Ask for: Joshua Brown-Araque
Email: Joshua.Brown-Araque@Ashford.gov.uk
Direct line: (01233) 330 442
Date: 14/05/2024
Ref: Parcels A, E, F, C2 & NG1 Land at Chilmington Green

RE: REF: Quality Monitoring Site Visit: *Parcels A, E, F, C2 & NG1 Land at Chilmington Green, Ashford Road, Great Chart, Kent*

I am the Quality Monitoring Officer at Ashford Borough Council and I am based in the Placemaking Team within Spatial Planning and the Planning and Development Department. It is my role to help ensure that all aspects of the quality of the Developments at Chilmington and South Ashford Garden Community meets the high planning and design expectations originally envisaged here.

4) The norther edge of the site nearest to bund/banks alongside the A28 (NG1), a singular street tree has died/broken

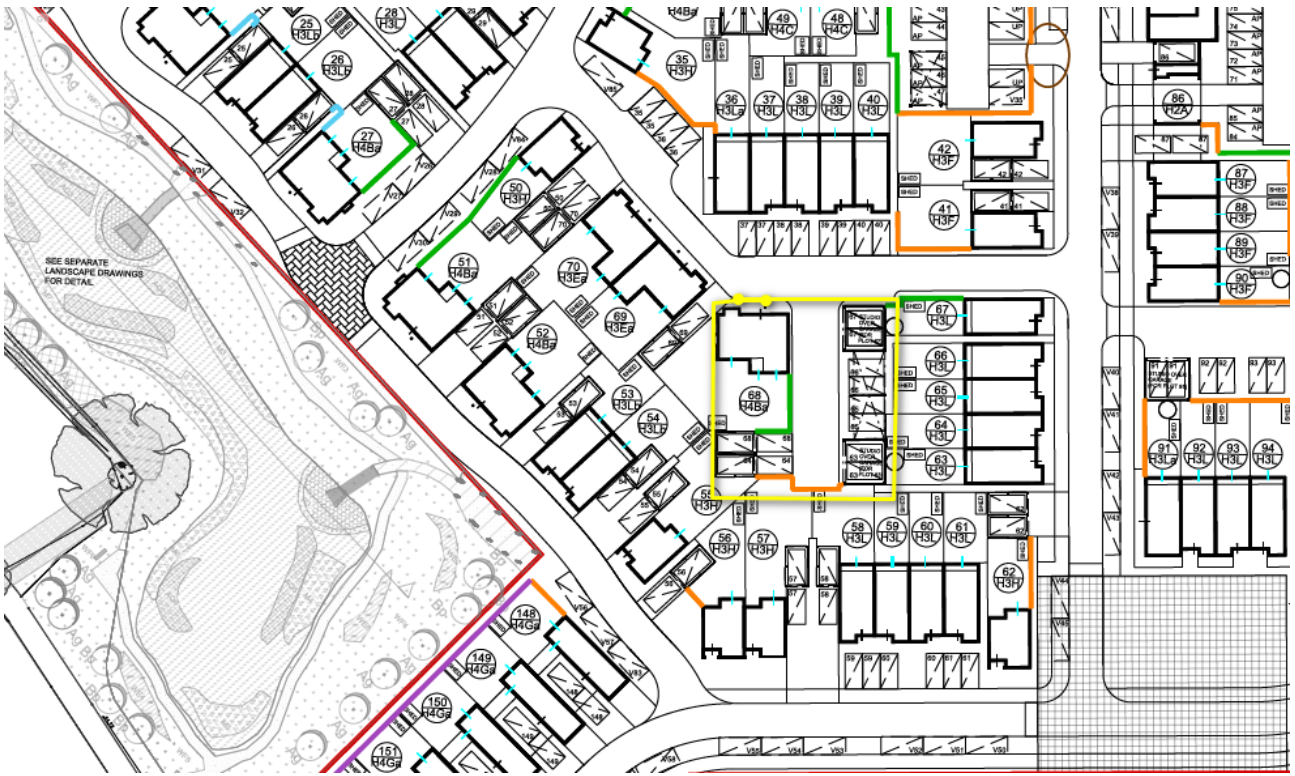
- 4) To the norther edge of the site nearest to bund/banks alongside the A28 (NG1), a singular street tree has died/broken and is now at ground level. This tree is a part of a row of four trees and without this there is a gap in the row, the street trees are large in size and are a view point at the end of Green mews. It will need to be re planted to maintain the row of trees. ***(Please see below for photographs and location)***

- 5) To the south eastern corner of A, E and F is an area alongside plot 153 – large mature Oak tree (TPO).

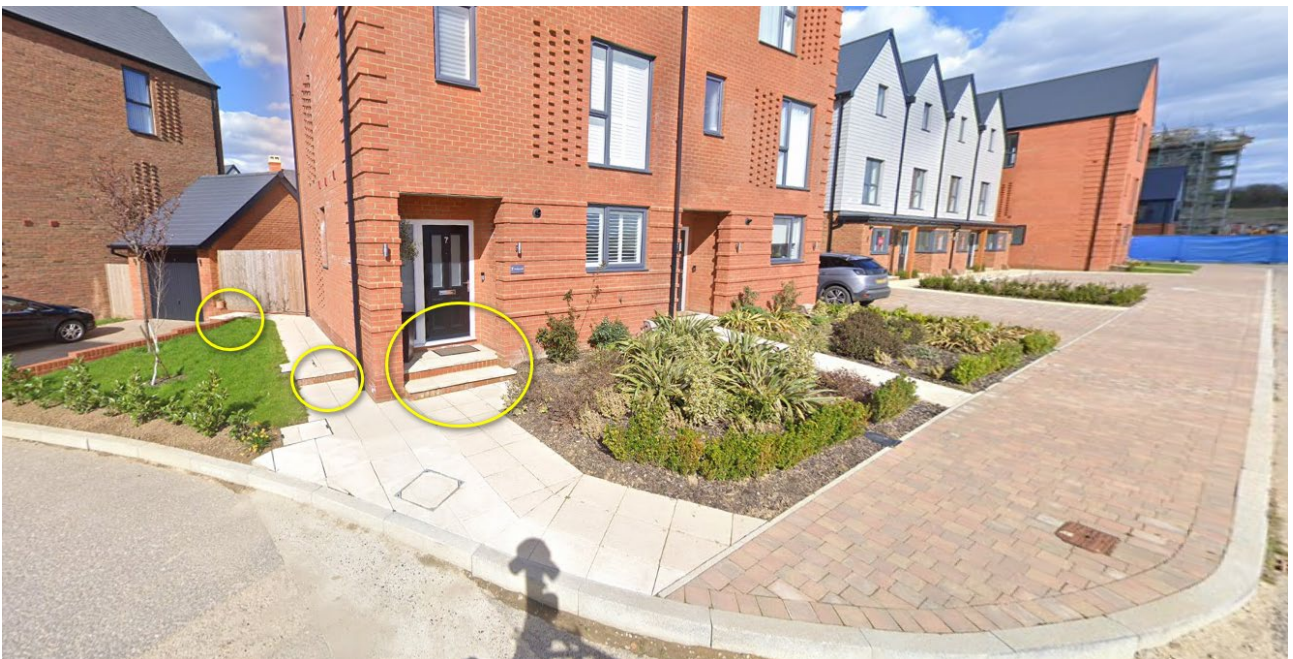
- 5) To the south eastern corner of A, E and F is an area alongside plot 153, there is a large mature Oak tree (Tree in situ on the site before development had started and TPO Tree), The tree is currently behind a close boarded fence with a pathway which goes around the tree and to the SuDs feature (C2) via two pathways, and in future development a highway will also loop around the tree. Currently this tree does have a pathway from the roadway but it does not look like what was originally proposed (LANDSCAPE GA SOFTWORKS 5 OF 5 - D301_110 C), there is harries fencing surrounding one side of the tree, no proposed litter bins seem to be in situ, and benches also seem to not be in situ in this area. Also proposed is further trees which also do not seem to be in situ. Please could you confirm when this work will be completed? This area is a key connection and open public space so it would be ideal to progress this area for residents currently living on site. ***(Please see below for photographs and location)***
